**SR 387233 - 59 KINGSFORD SMITH STREET**

**RFI RESPONSE**

ATTENTION: SOPHIE LORD  
SENDER: MIKE STONYER  
PROJECT: 59 KINGSFORD SMITH STREET  
RESOURCE CONSENT: SR387233

**Re: 59 KINGSFORD SMITH STREET  
Request for further information**

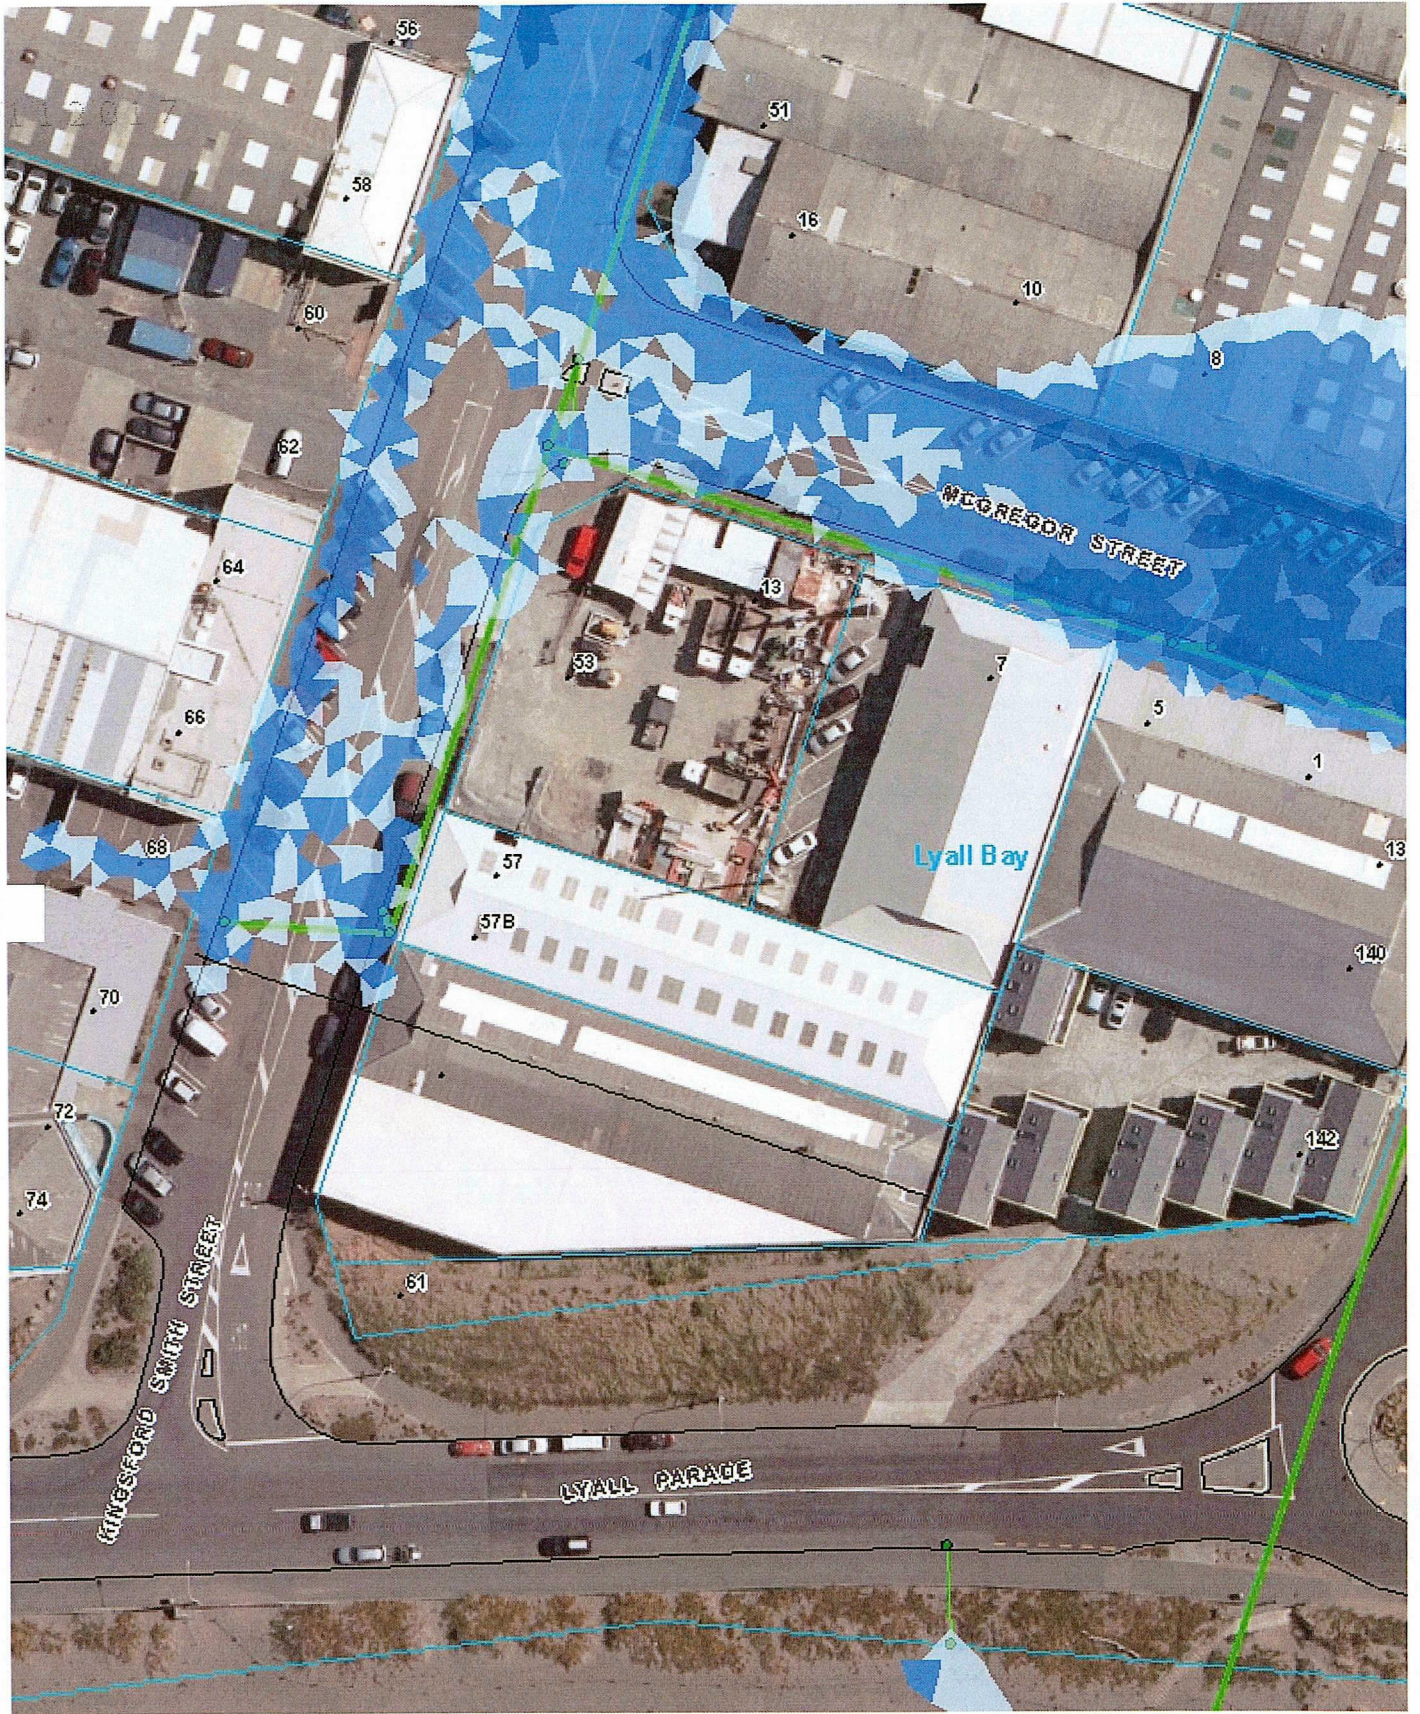
The issue of how flood water not entering the basement is something that needs to be resolved. You need to show a design of the ramp from the road to basement so that water from the road will not enter the ramp. You should also describe your proposal(s) how to make the basement watertight and dry.

Please see below the draft results from our model. The results don't include freeboard. We only have available results for 100yr and 10yr events (no climate change).

Peak water level (no freeboard) along Kingsford Smith St (in front of no.57) is about 4.5m. Peak water level (no freeboard) along McGregor St is about 3.9m (in front of no. 5)

TITLE:  
WASTE WATER DRAINAGE  
CATCHMENT PLAN

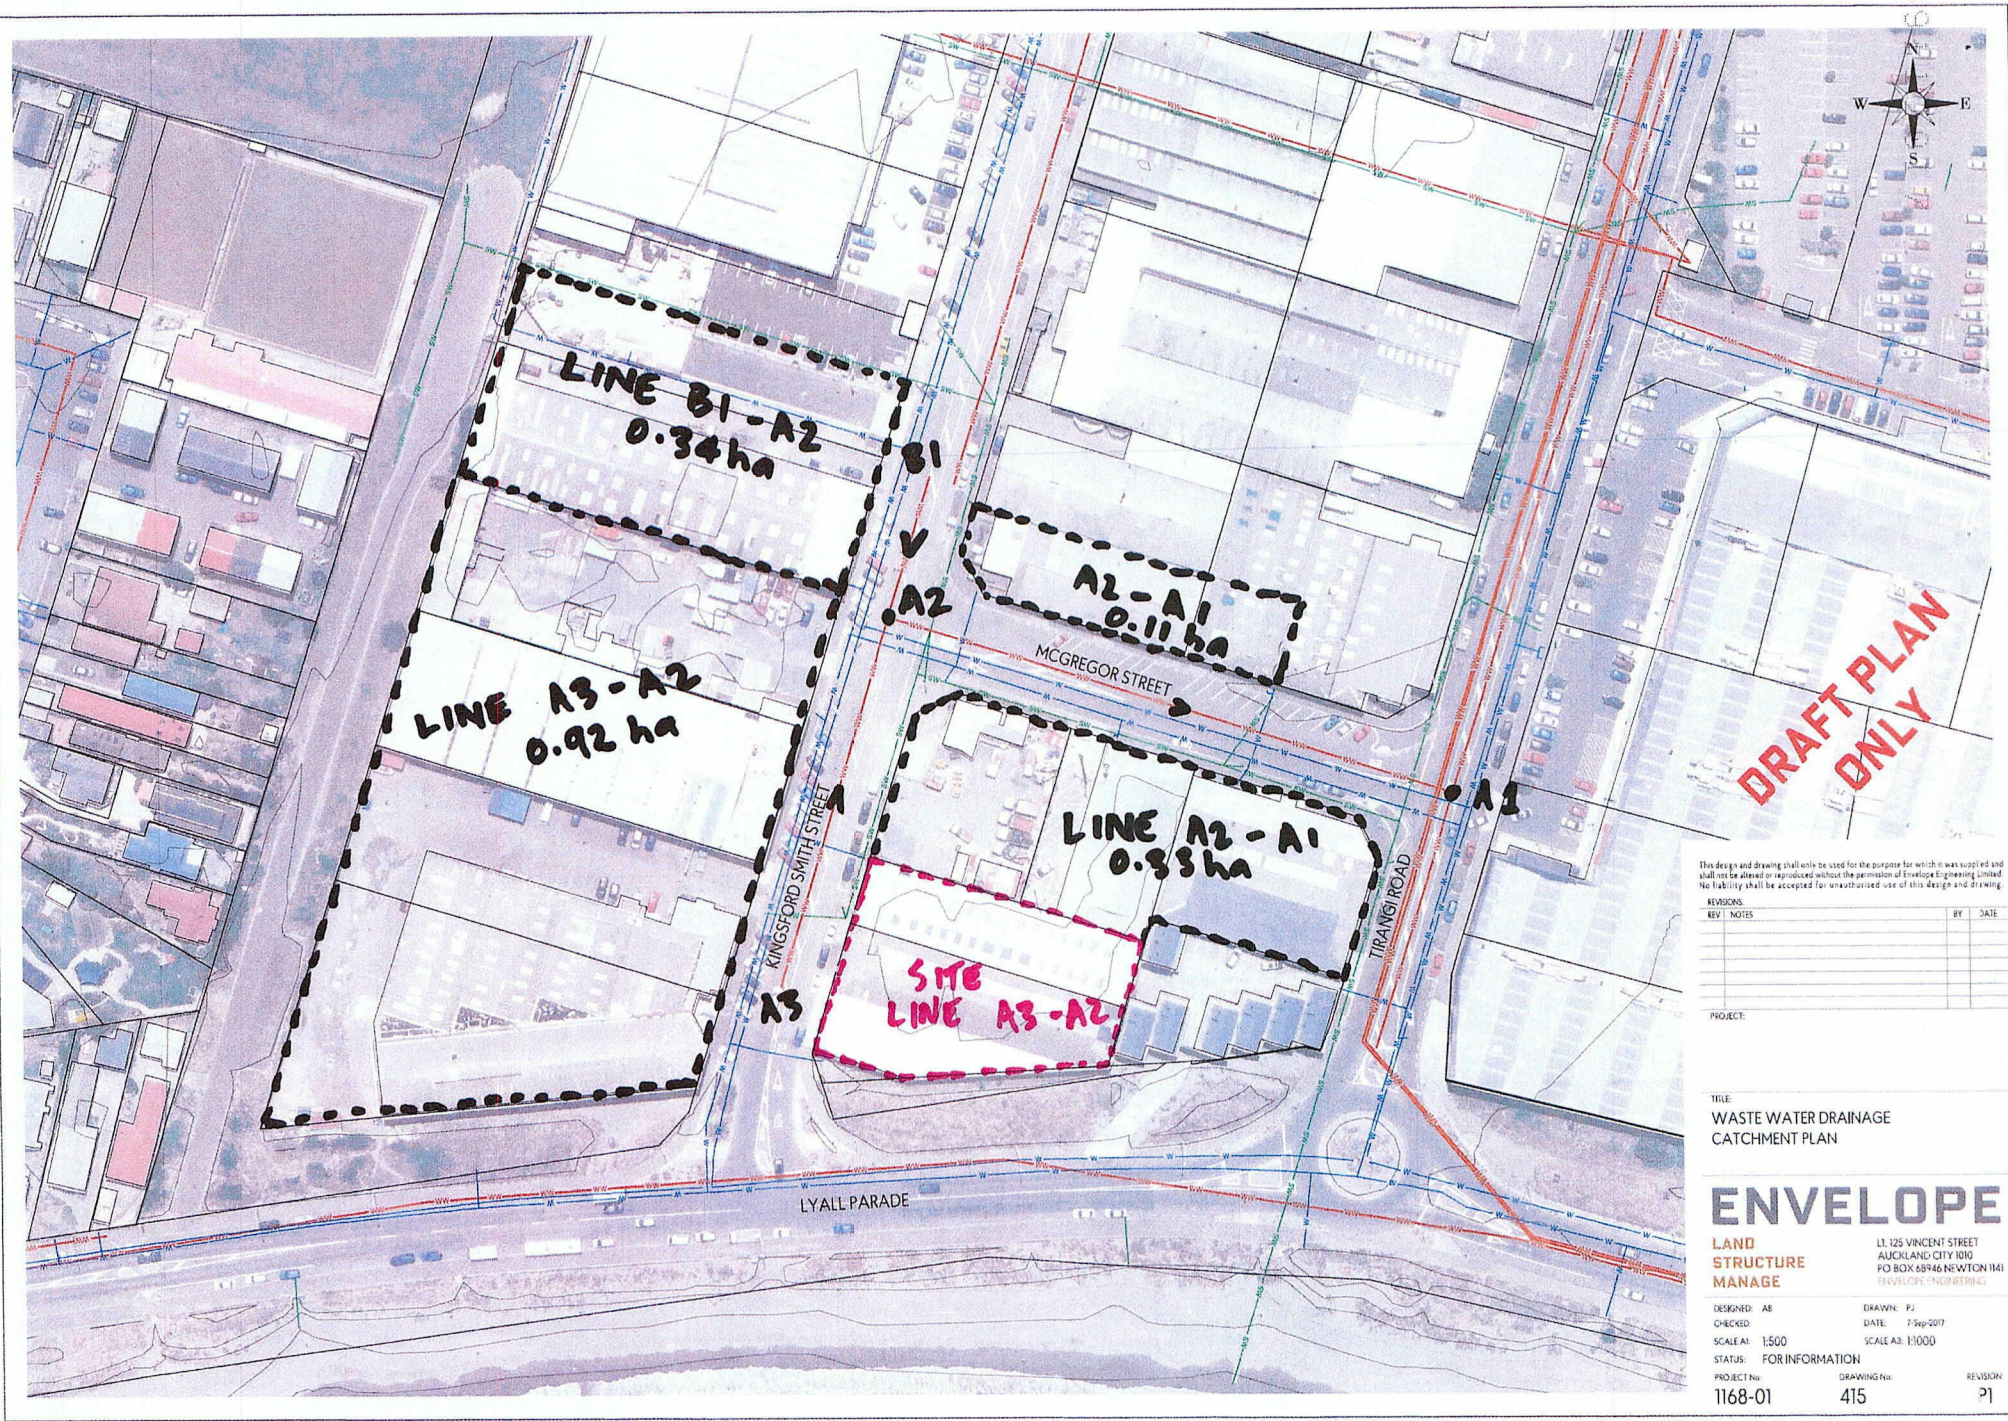
Our Infrastructure Plans 1168-01-415 in Appendix 2 attached shows the proposed new private drainage line connecting to the existing public wastewater manhole noted A3 in Kingsford Smith Street.
